UTAH DIVISION OF OIL, GAS AND MINING

WELL NO. Cisco Federal #9

APPLICATION FOR PERMIT TO DRILL, DEEPEN, OR PLUG BACK

USUAL ENVIRONMENTAL ASSESSMENT

LOCATION PLAN FOR
 CISCO DRILLING & DEVELOPMENT CO.
 CISCO WELL # 9
 N.1/2 SEC. 34-20S.-23E.

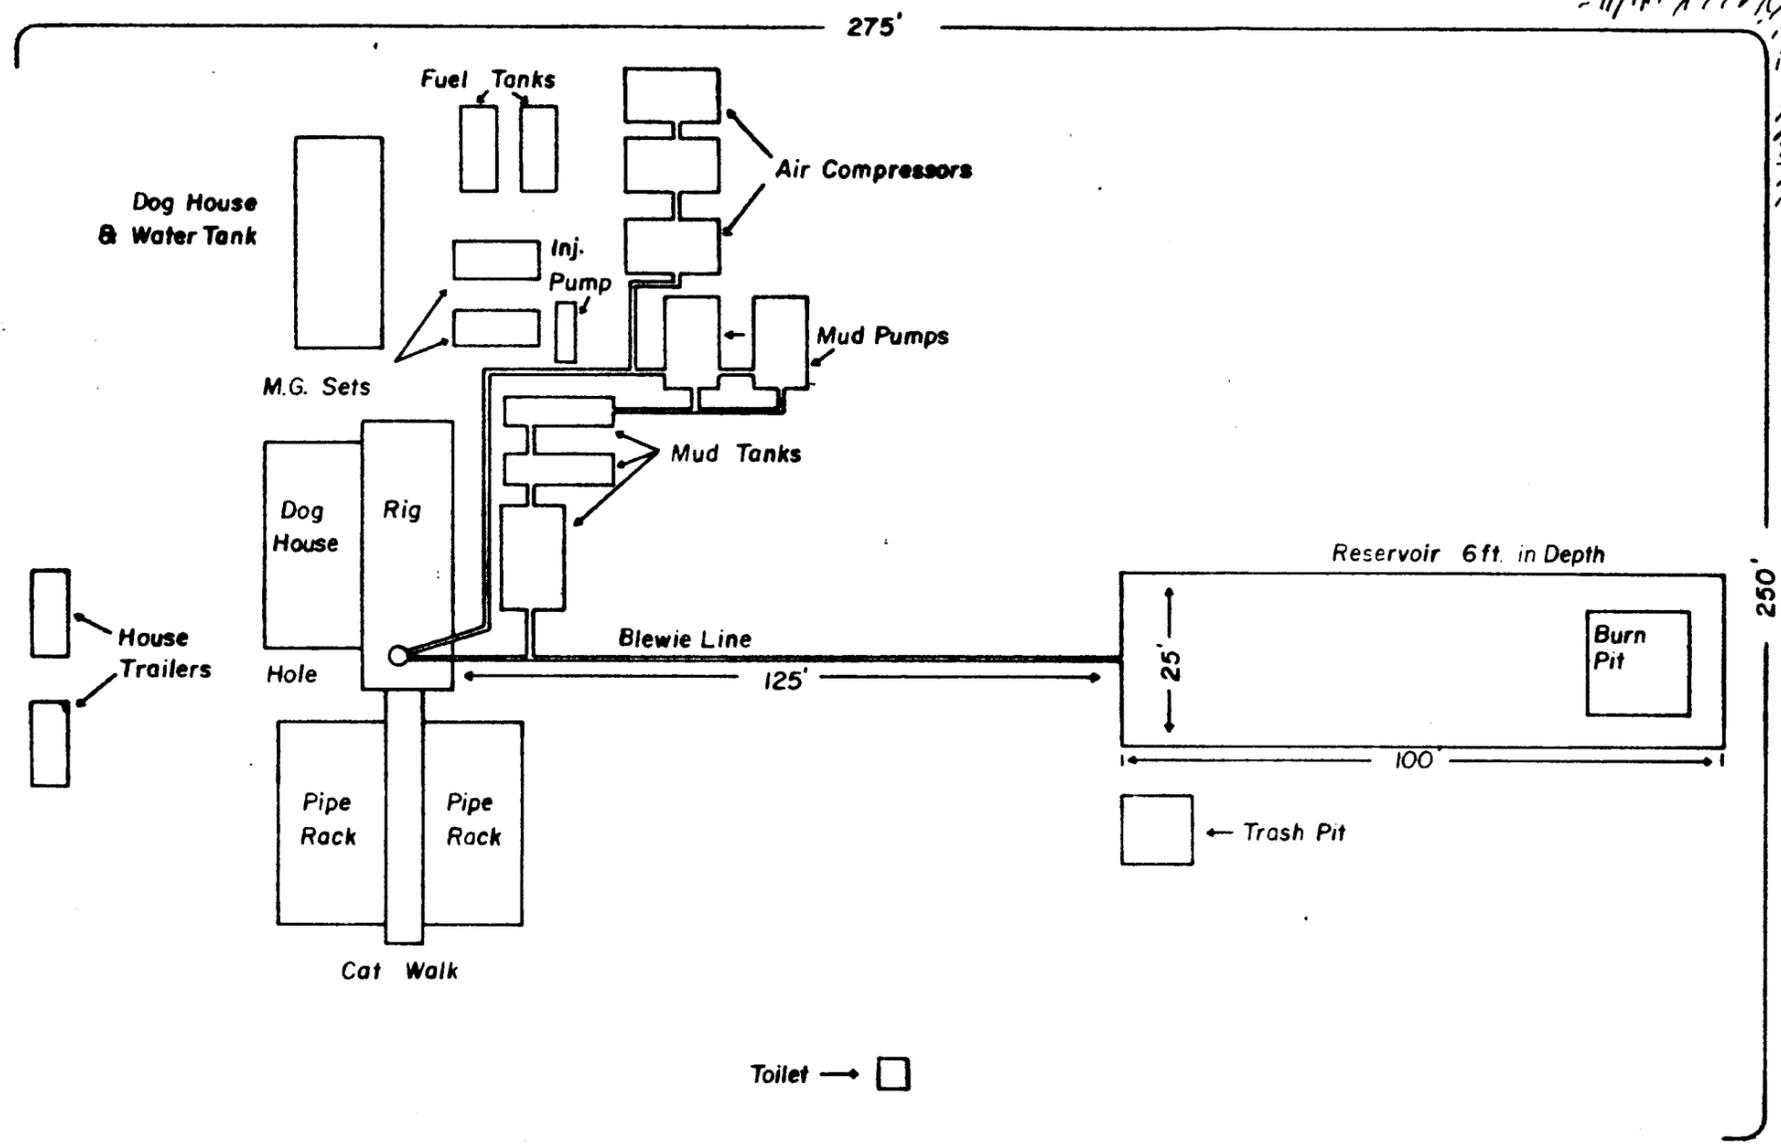
An objection was raised to the wellsite orientation. The proposed plan placed the reserve pit in a wash and in approximately 6' of fill. To reduce the chances of a spill and/or the potential for significant siltation, the operator's representative agreed to rotate the rig 90° to the west in order to locate the reserve pit in cut. There was no objection raised to the access road.

Enlargement of the reserve pit was suggested by USGS and BLM. Reasoning for this is based on recent experiences by some operators in the Cisco Springs area who have encountered as much as 50 barrels of water/day when drilling in proximity to faults. The operator's representative was unaware of the subsurface structural aspects of the site, as were the government agencies. Therefore, in the interest of making certain that the reserve pit had the capacity to handle fluids in significant quantities, its dimensions were expanded to 25' wide x 100' long. The operator agreed that this was appropriate. Additionally, the operator requested enlarging the pad dimensions to 250' x 275'. This was agreed to by USGS and BLM.

Several small intermittent drainage channels cross the wellsite. One main, dry channel borders the location on the east and it is this drainage that was the cause for rotation of the rig.

- a) To avoid the drainage on the east, operator will rotate the rig 90° to the west. This will place the reserve pit in cut, not fill.
- b) Operator will fence the reserve pit on three sides prior to drilling, and on four sides once the rig has moved off.
- c) Operator will stockpile 8" of topsoil on the SW corner of the location.
- d) Operator will maintain the blooie line at least 125' from the wellhead and direct it into the reserve pit.
- e) Operator will enlarge the reserve pit to 25' wide x 100' long to contain any fluids.
